February 03, 2012

Re: **TRI-COUNTY COUNCIL / SHORE TRANSIT BUS MAINTENANCE FACILITY
PHASE II**
Salisbury, Maryland
2009145.00

ADDENDUM FOUR

REVISED DOOR SCHEDULE

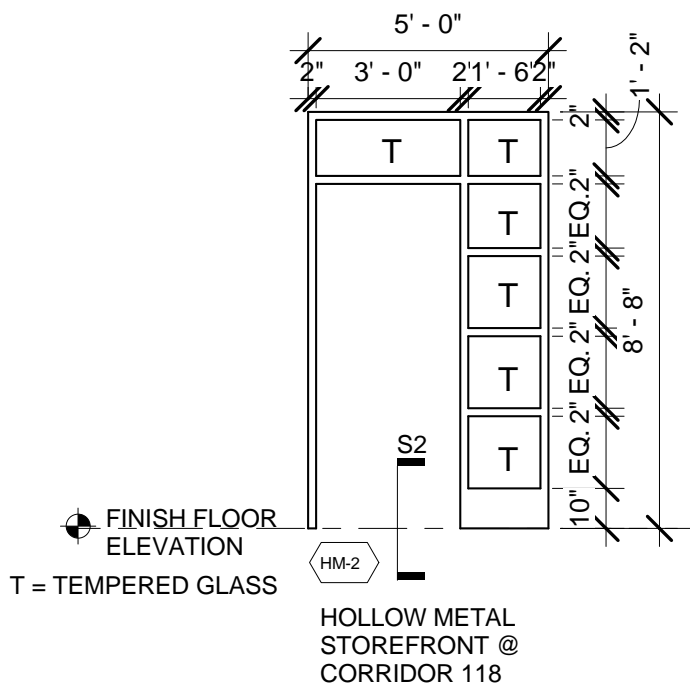
1. SHEET – A101 – FLOOR PLAN (BMG)
 - a. REVISE door frame of door 1/120 (Break Room) as shown in sketch MTA-SK-5 dated 1/31/12 issued via this addendum

- a. ADD door frame HM-2 as shown in sketch MTA-SK-5 dated 1/31/12 issued via this addendum
 - b. REVISE door 1/120 as shown in sketch MTA-SK-5 dated 1/31/12 issued via this addendum.
